Planning and Zoning Commission - Special Meeting AGENDA

**STAFF REPORT
KETCHUM PLANNING AND ZONING COMMISSION
MEETING OF JULY 27, 2021**

Exhibit A:
Crossbuck McNee Townhomes
Project Plans

1 EAST SIDE ELEVATION (UNIT A)
A-5A 1/4" = 1'-0"

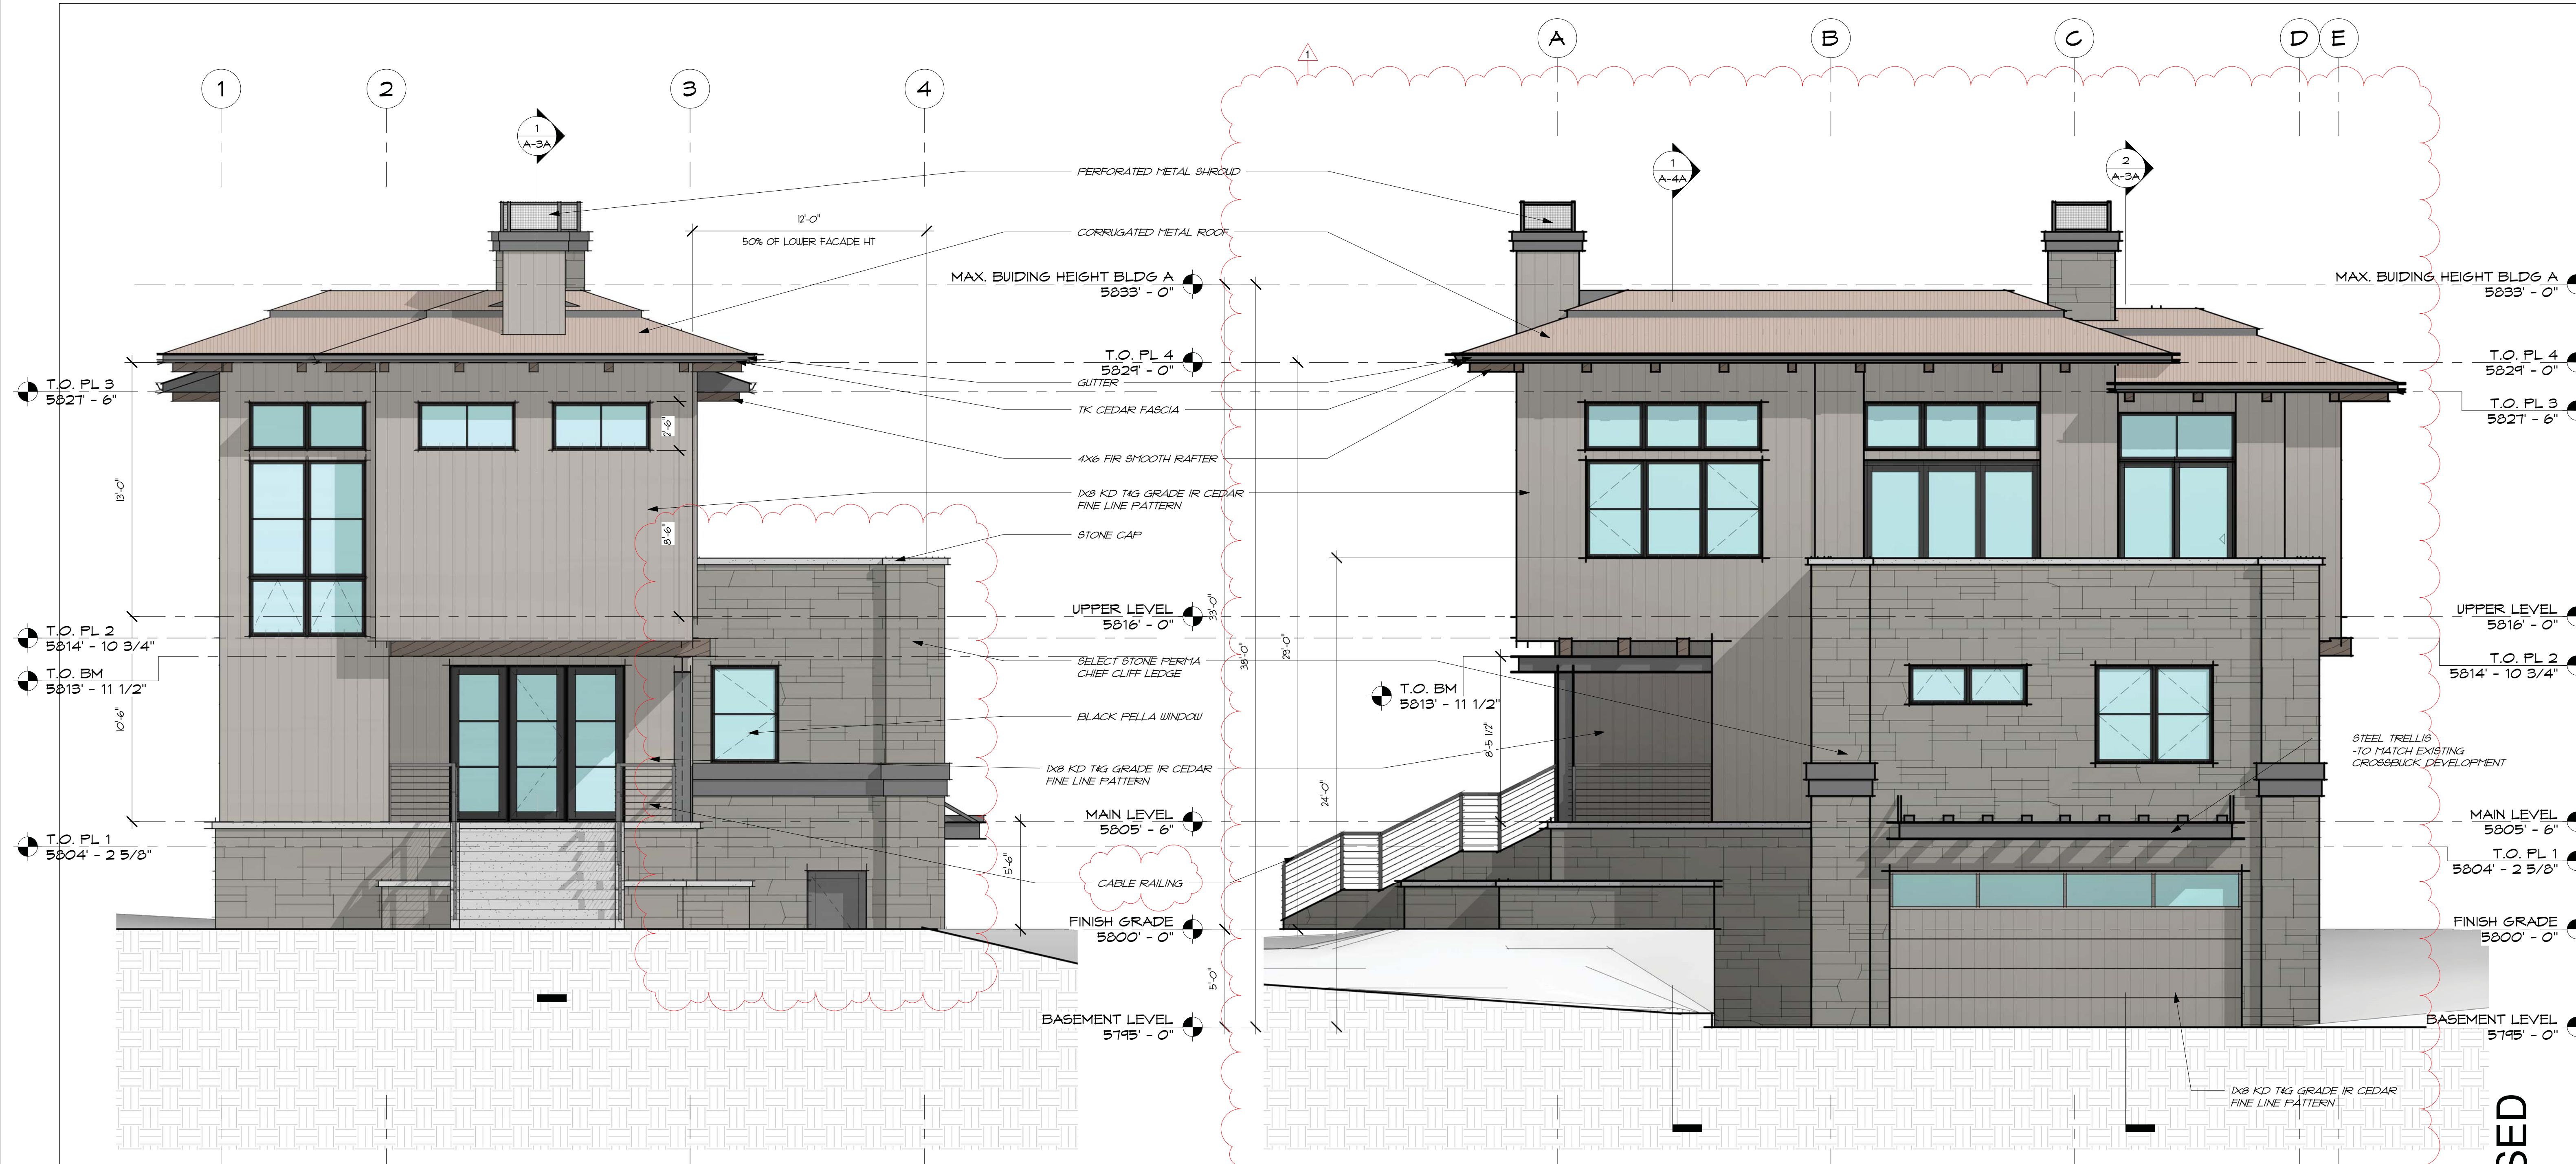
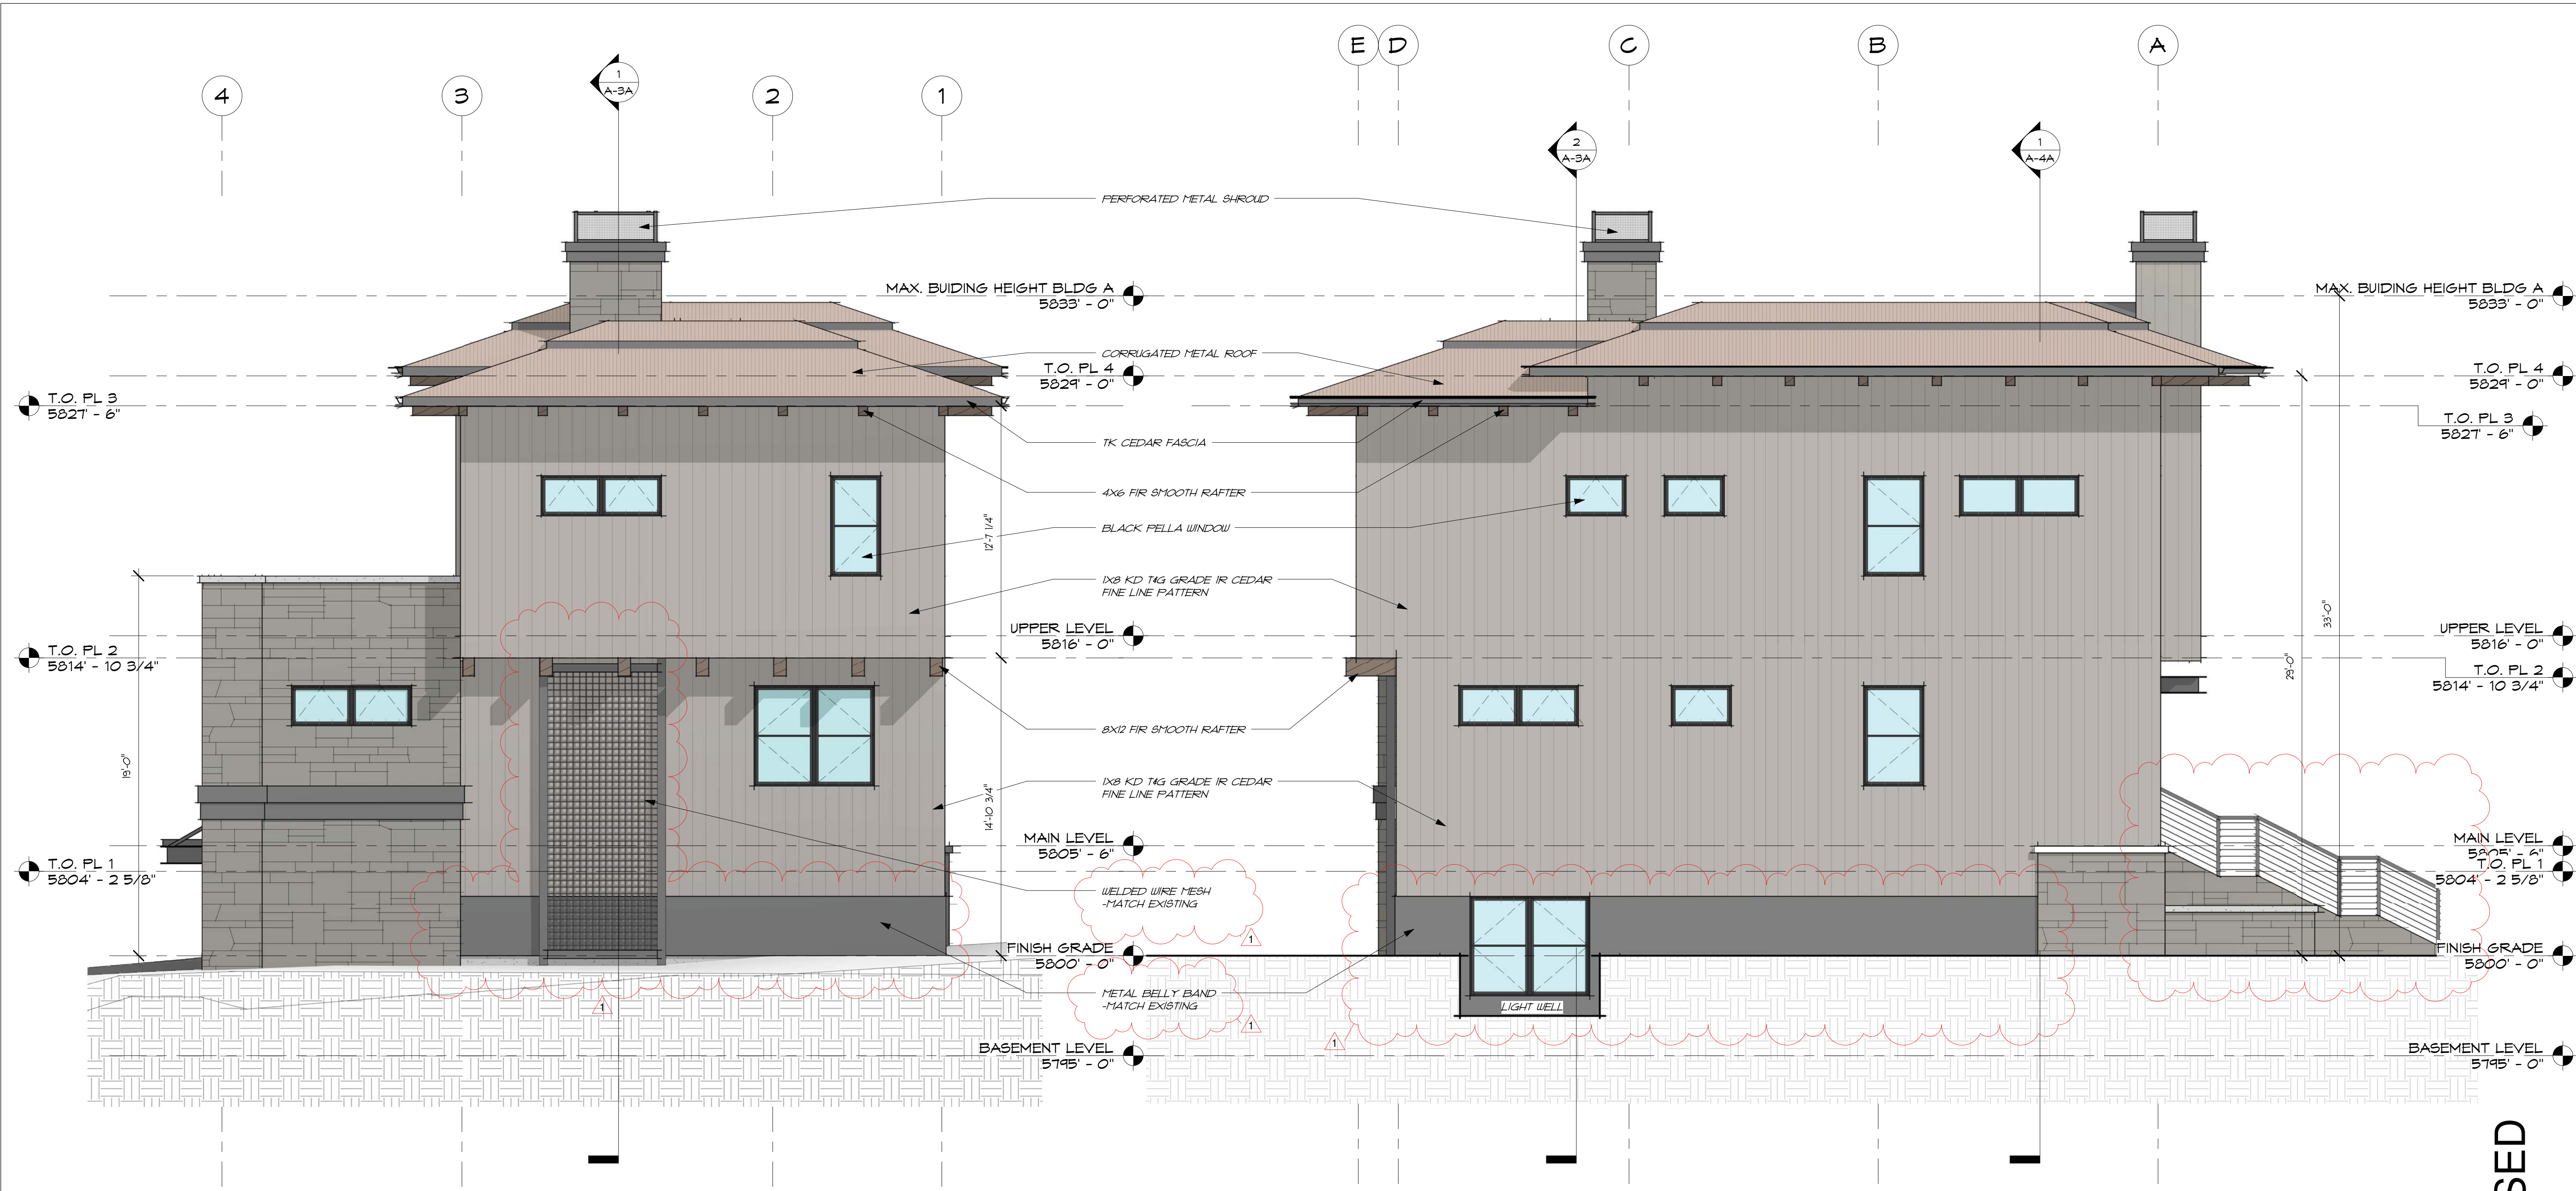
The material differentiation and an upper-level setback created by the second-floor deck do not provide sufficient visual relief from the building mass. The lack of articulation and variation produces areas of uninterrupted, blank walls. The unbroken façades reinforce the bulk and mass of the townhome units.

<p>the McNee townhomes does not provide enough visual relief to mitigate the appearance of blank walls at the street-side facades. The existing Crossbuck units utilize the placement of stone veneer more effectively. For example, the existing Crossbuck units' entire chimney is clad in stone veneer. This creates a prominent column that vertically integrates each floor and grounds the townhomes to the project site. The use of stone veneer proposed with the McNee townhomes is limited to one- and two-story elements. More exterior material differentiation and fenestration is needed to provide visual interest.</p>
<input checked="" type="checkbox"/>	<input type="checkbox"/>	<input type="checkbox"/>	<p>17.96.060.F3 Architectural</p> <p>There shall be continuity of materials, colors and signing within the project.</p>	<p>Staff Comments</p> <p>As noted on Sheet MB, the Crossbuck McNee Townhomes will match the existing Crossbuck Townhomes developed on the remainder of Block 67. All townhome units share the same exterior material patterns and color palette.</p> <p>The proposed exterior materials include metal clad windows, corrugated metal roofing, steel frame awnings, concrete and gabion site walls, vertical wood siding, steel posts and beams, steel wainscot, and stone veneer. The stone veneer and wood siding are shades of gray. The steel posts and beams, trellises, and metal trim are dark gray and brown. The darker colors contrast with the lighter gray wood siding and stone veneer adding more articulation to the façade design.</p>

The material differentiation and an upper-level setback created by the second-floor deck do not provide sufficient visual relief from the building mass. The lack of articulation and variation produces areas of uninterrupted, blank walls. The unbroken façades reinforce the bulk and mass of the townhome units.
<input checked="" type="checkbox"/>	<input type="checkbox"/>	<input type="checkbox"/>	17.96.060.F6 Architectural	Building(s) shall orient towards their primary street frontage.
			Staff Comments	The townhome units include covered entryways that orient towards the 2 nd Avenue. These covered entryway landings lead to paver walkways that connect to the bike path along 2 nd Avenue.
<input checked="" type="checkbox"/>	<input type="checkbox"/>	<input type="checkbox"/>	17.96.060.F7 Architectural	Garbage storage areas and satellite receivers shall be screened from public view and located off alleys.

After considering the project plans attached as Exhibit A, the applicant's presentation, staff's analysis, and any public comment received, Staff recommends the Commission provide feedback to the applicant and move to continue review of the Design Review application to a date certain.

1 EXHIBIT A REFLECTING COMPLIANCE WITH ILLUSTRATION B
 A-7A 1/4" = 1'-0"

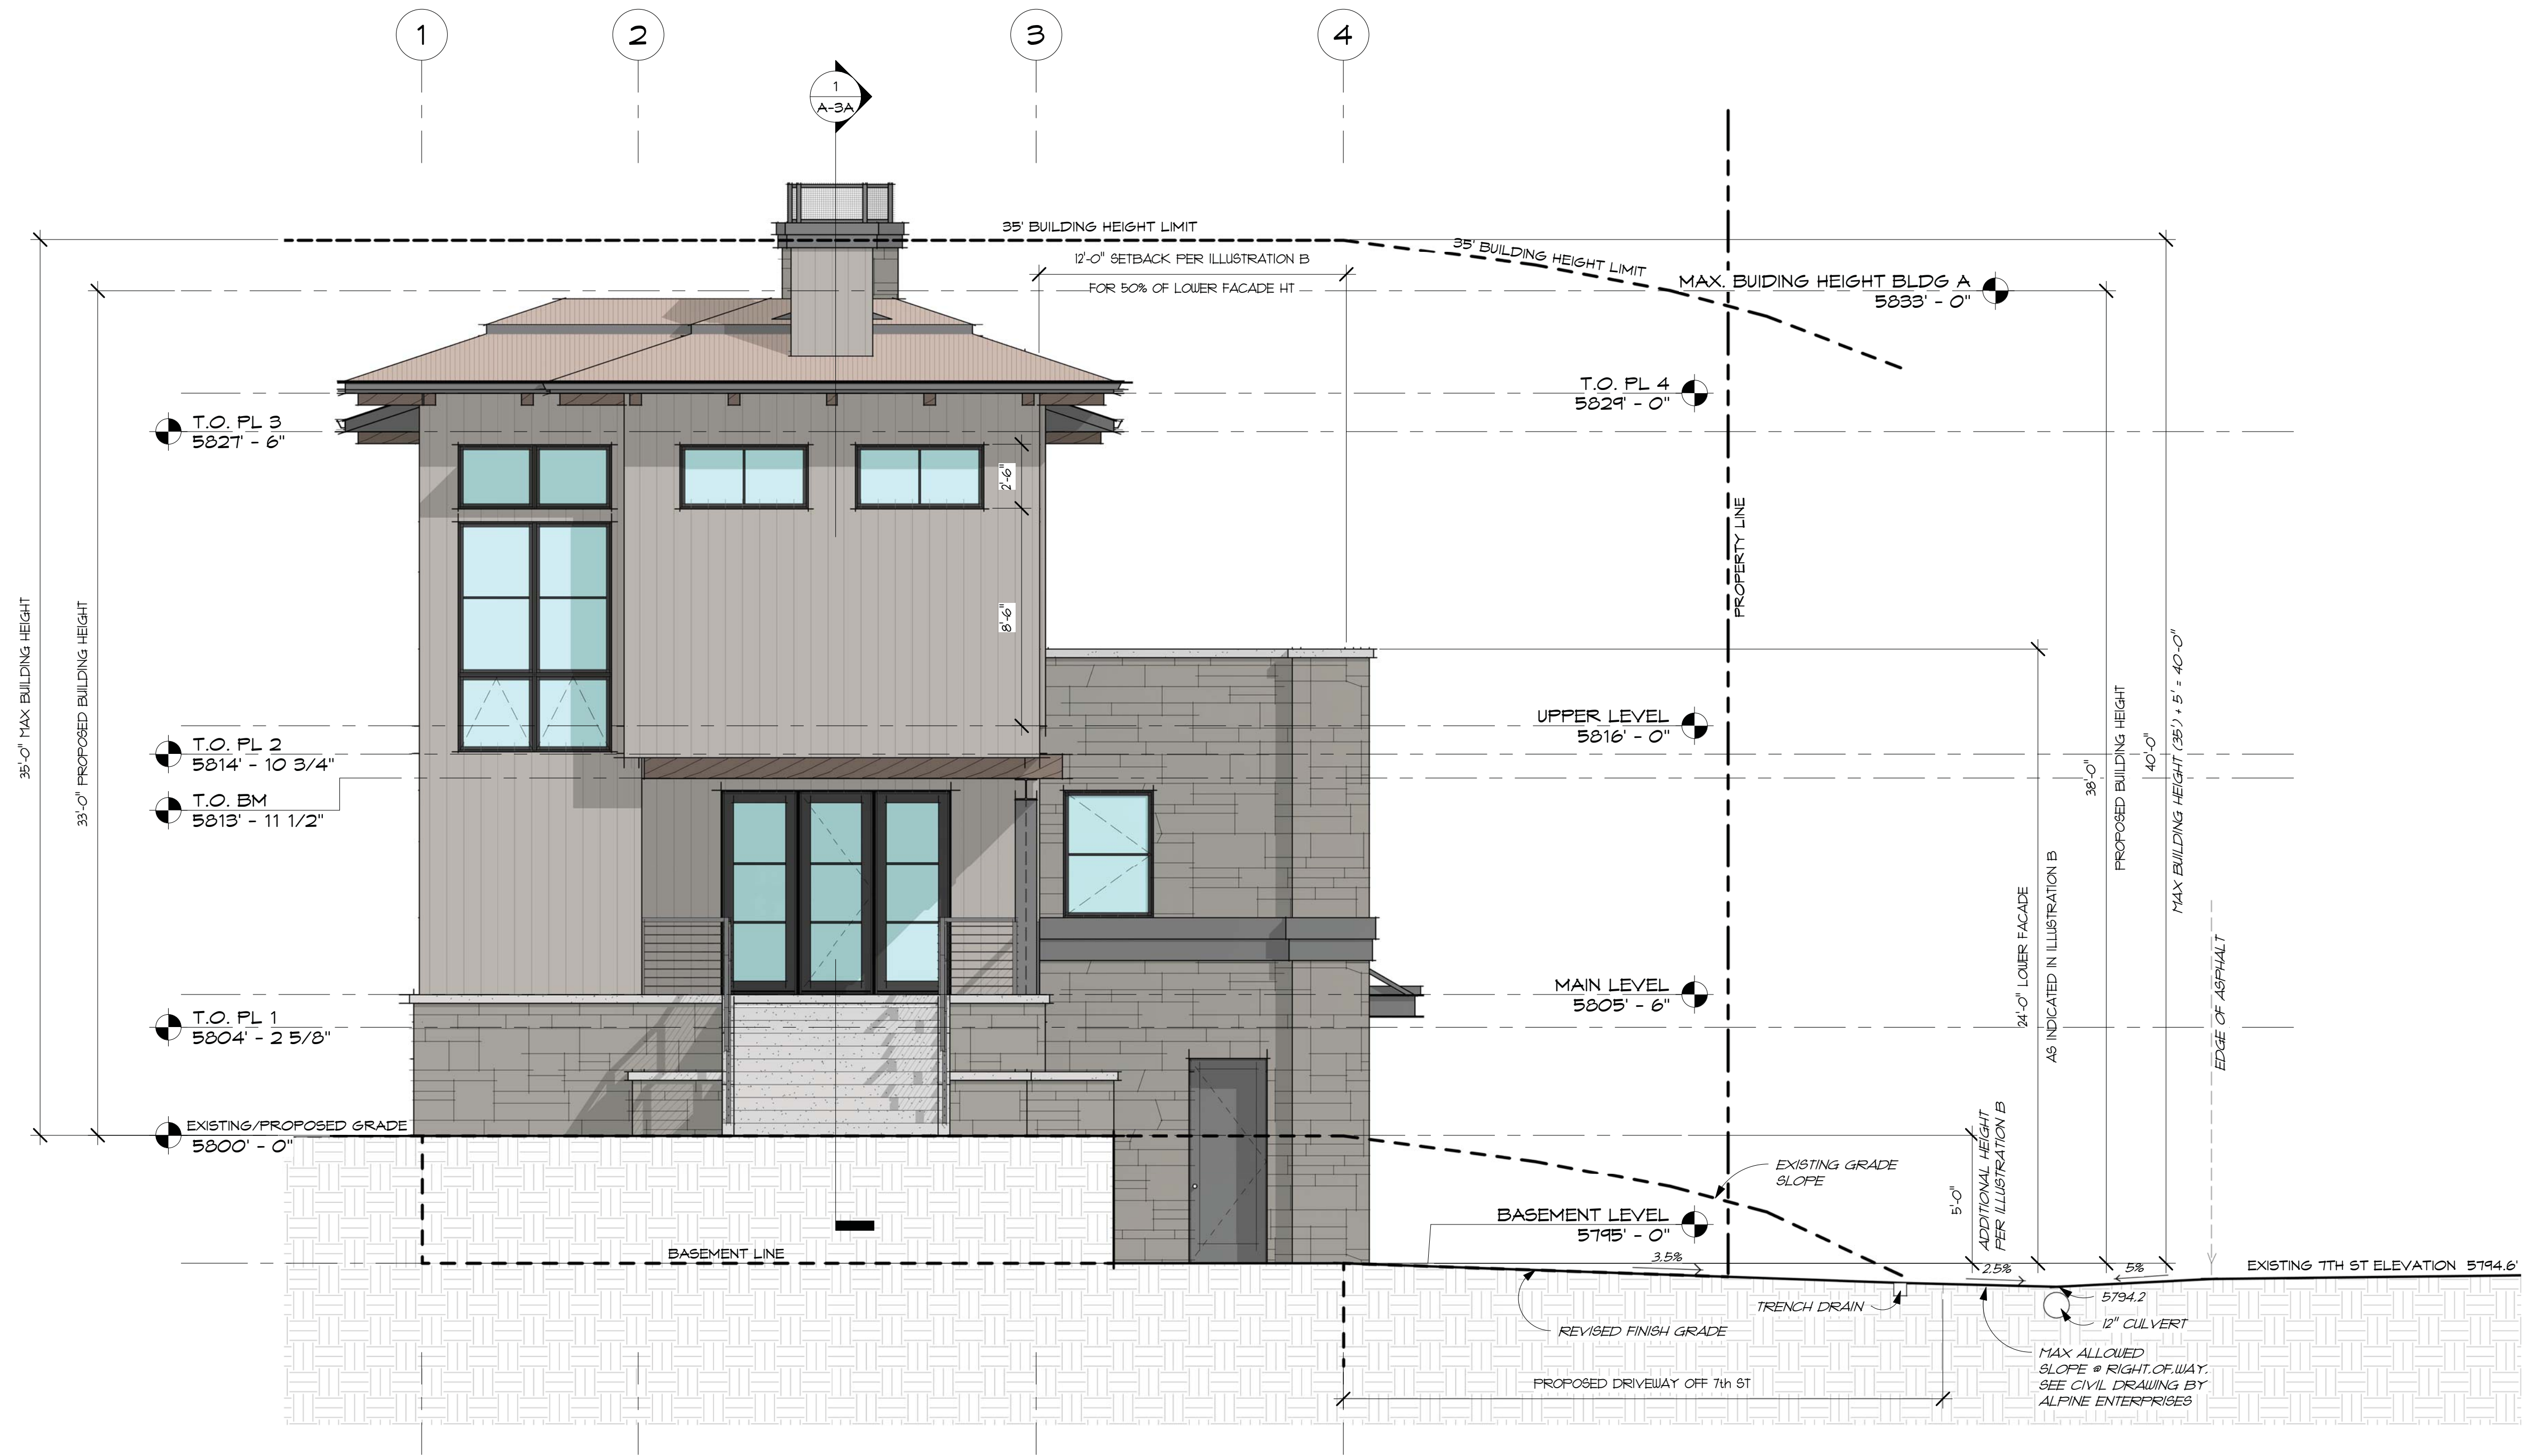
The townhome units are boxy and bulky buildings. Unlike the existing Crossbuck units and the townhome units proposed on adjacent Lot 2A, the McNee units have maximum building heights of 35 feet and 38 feet in height. As shown on Sheet A-7A of the project plans, townhome unit A takes advantage of the additional 5 feet of building height provided for in Ketchum Municipal Code §17.08.020 due to the topography of the site. The maximum height of townhome unit A from lowest grade to highest point of the roof is 38 feet. The mass of the building's rectangular volumes is overbearing. The design utilizes
